Request for Further Information Response Register

MH CI 23 PPC84 PF 2023 04 06

Mangawhai Hills, Tara Road, Cove Road, Old Waipu Road, Moir Road.

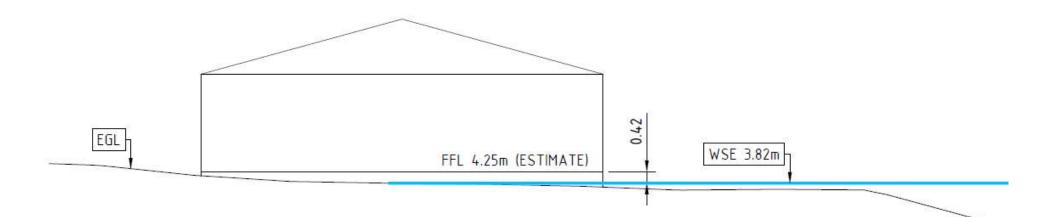
4.	Please verify flood models based on levels from the recent weather event in Mangawhai (24th February 2023). It's noted that there is a potential risk of flooding at 114 Moir Street, which could be cumulatively impacted by the proposed development. Given the low accuracy of hydrological models, there may be value in using this recent information as confirmation of the calculated flood levels	The client has since been to visit the property to speak to the resident and enquire about recent flooding events experienced in February 2023. It was reported by the resident that flood waters approached 'within 100mm' of the FFL on February 27th 2023. It is unclear if this was measured accurately and is anecdotal. In order to test this through flood modelling, rain gauge data made available by NRC has been used against our HEC-RAS existing coverage model. The rain gauge closest to the property is referred to as 'Hakaru at Tara' approximately 9km from the site. No storm event was recorded for 27th February, however the Cyclone Gabrielle event on 24th February 2023 shows rainfall of 398mm over a 24 hour period. This has been used as the rainfall for our test model. We have applied some refinement of the model's Mannings numbers in this area to provide as much accuracy as we can at this early stage in the design. We note that we do not have topographical survey, and floor levels are estimated from the LINZ lidar ground model. We have added in the bridge structure to the south of 114 Moir Street, but note that the dimensions of this are best guess at this stage and are yet to be confirmed before we proceed with a more detailed flood model at RC stage. The resultant water surface elevation from this test model is 3.82m. Our assumed FFL of 114 Moir Street is 4.25m, resulting in a freeboard of 0.42m, which is lower than the anecdotal level provided by the resident. Given the lack of accurate survey data in this area and anecdotal nature of estimated flood level by the resident, a variance of several hundred millimetres is not unexpected.
